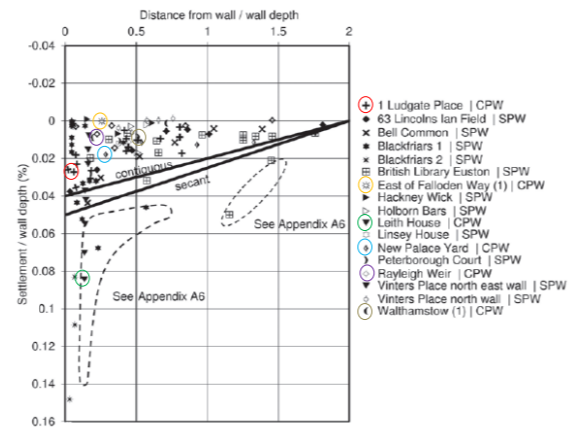
This is the critical section line I was thinking of; away from a corner but still 3.3m from South Mansions. Perhaps this could be assessed in addition to Critical Section 1 to ensure the worst case scenario is definitely captured.
